RESPONSES TO
NRC QUESTIONS
ON THE
MONTICELLO PUAR

PREPARED BY
NUTECH ENGINEERS, INC.
SAN JOSE, CALIFORNIA

PREPARED FOR
NORTHERN STATES POWER CO.

NRC QUESTION ON MONTICELLO PUAR
HYDRODYNAMIC LOAD RESPONSE

Figure 21 - 20"φ

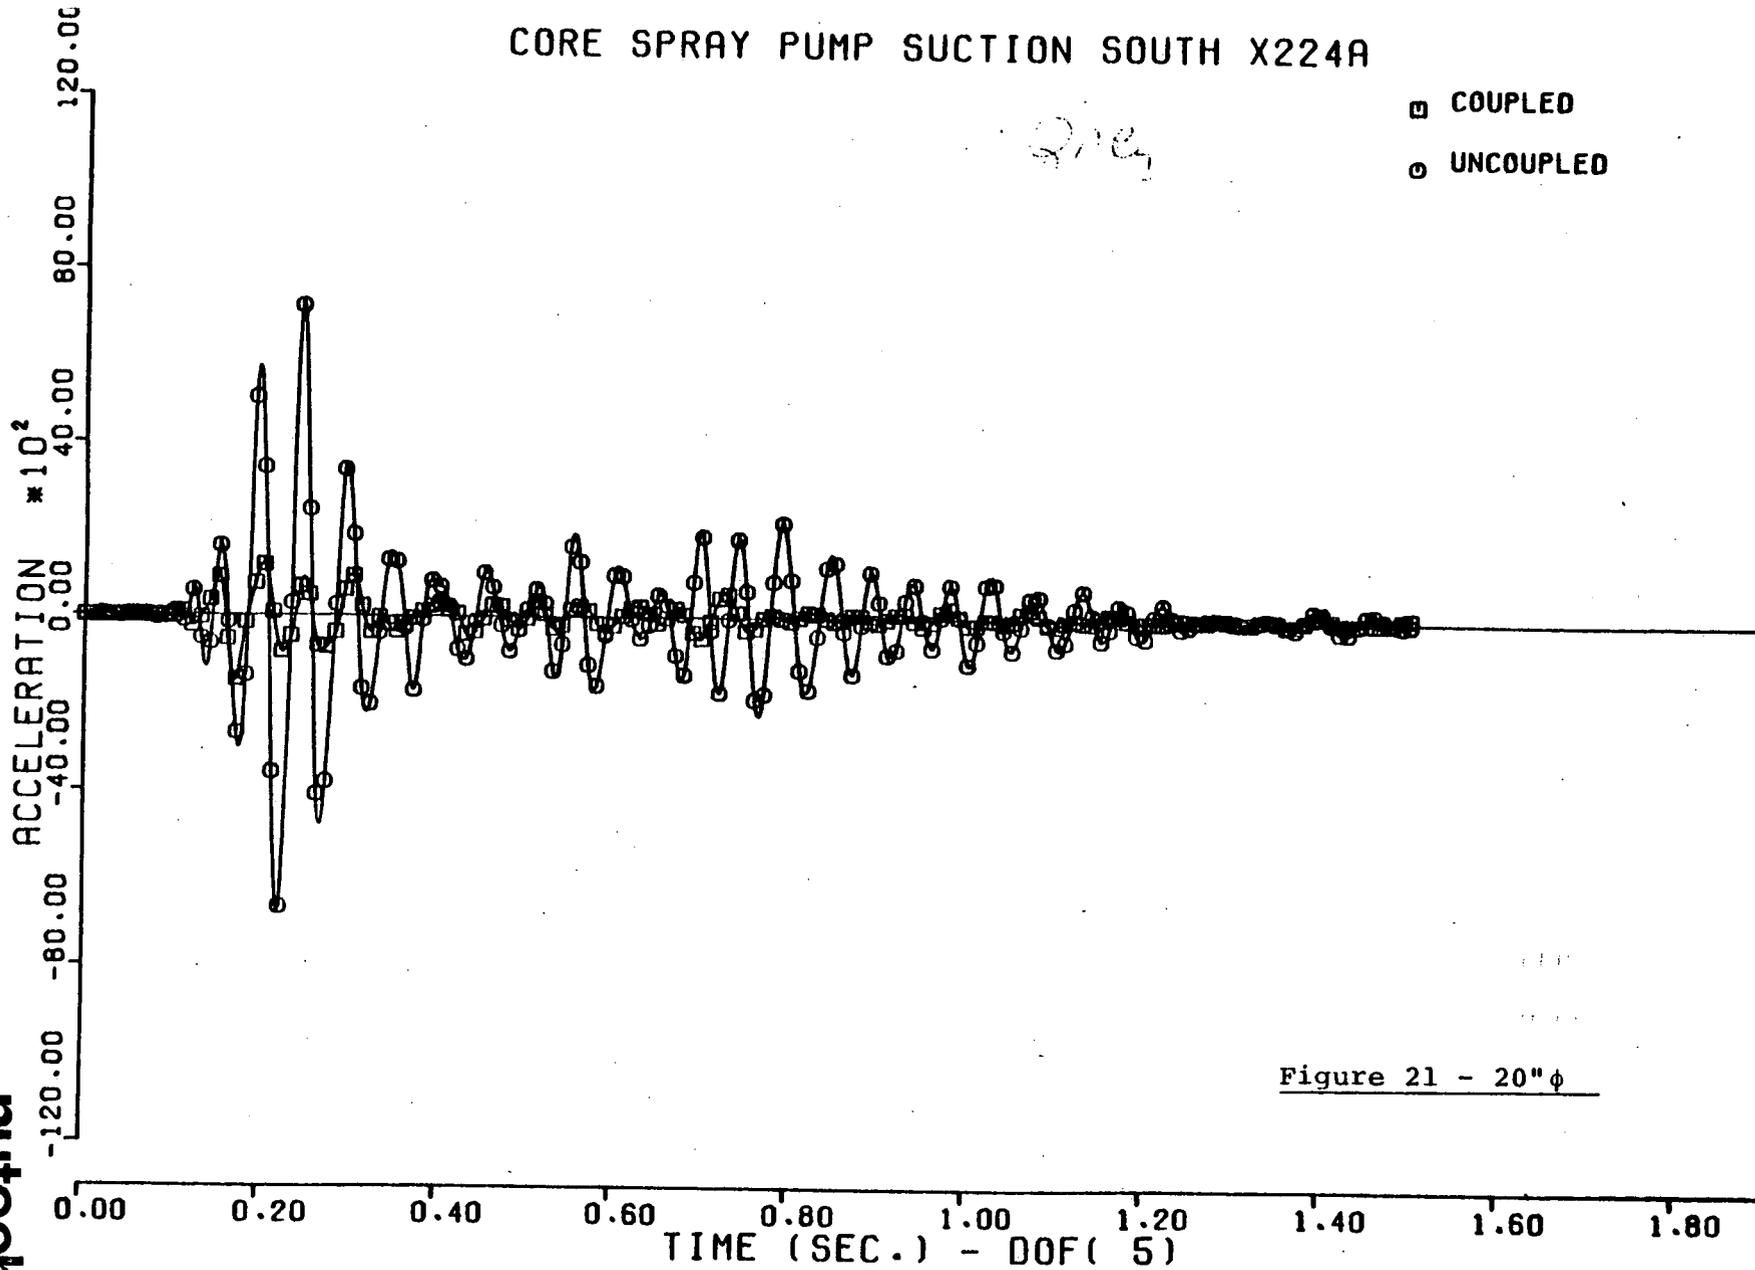
ITEM 12: The computer code CMDOF has been used in the torus attached piping analysis for all plants that utilized NUTECH as their contractor. With regard to the code provide the following information:

- 1) Theoretical background of CMDOF computer program
- 2) Program verification
- 3) Applicability of the computer program to the torus attached piping analysis.

To illustrate the effect of pipe size on coupling, four typical piping systems were examined and the coupled and uncoupled time histories plotted together. These time histories include both the smallest (2") and larger (20") systems analyzed. Listed below are the figure numbers and the corresponding line size.

Figure 4-8	2" diameter
9-13	4" diameter
14-18	6" diameter
19-21	20" diameter

These plots confirm the expected variation of coupling benefit with pipe size.
